MINING DEALER BEST PRACTICE

Pipe Rack Interlock Switch on MD6290, MD6240 and MD6420 Models

March 2023
1.04-230308-1

Picture 5: Details of change the by-pass switch

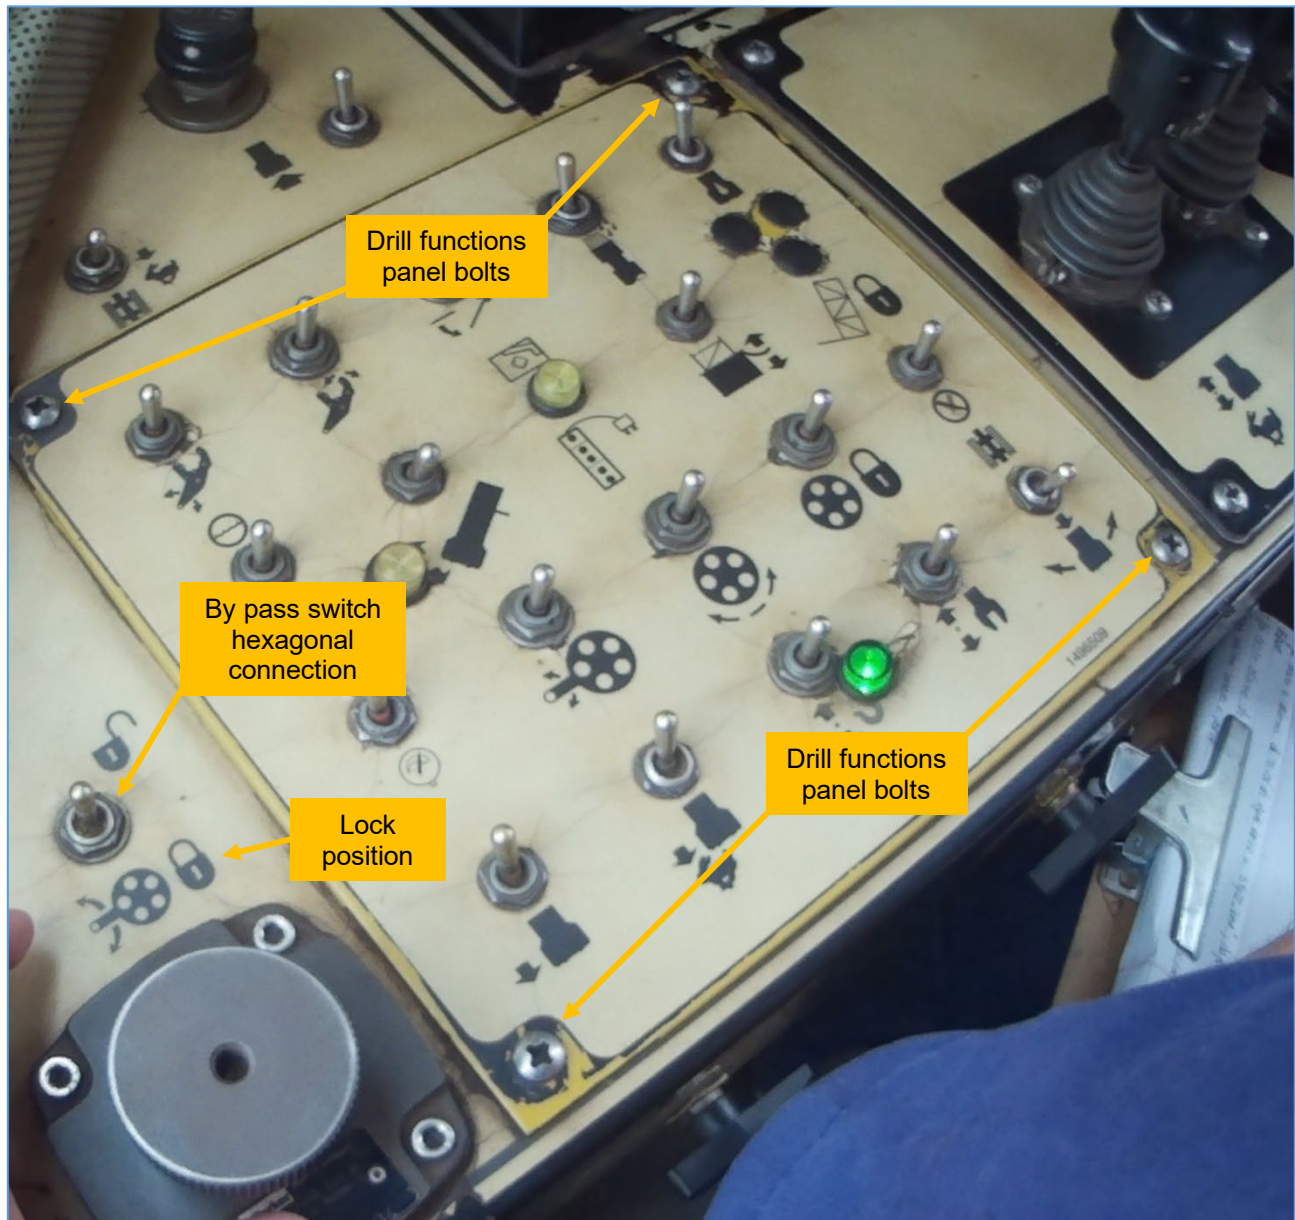
The picture 5 shows details of this installation.

1. Stop and shutdown the machine. Lock the safety device preventing switch, apply a warning sign.
2. Using a screwdriver, remove the installation bolts of the drill functions panel.
3. Access the electrical terminals of the by-pass switch and disconnect them.
4. Using a 1/2" open-end wrench at the hexagonal connection of switch, remove the original by-pass switch.
5. Using the same open-end wrench, install the new by-pass switch. Note: the normal position of this switch is in the lock symbol.
6. Connect the electrical terminals.
7. Using a screwdriver, install the drill functions panel.
8. Open the safety device preventing switch and turn on the machine.
9. Test the new by-pass switch installed in the pipe rack interlock system.
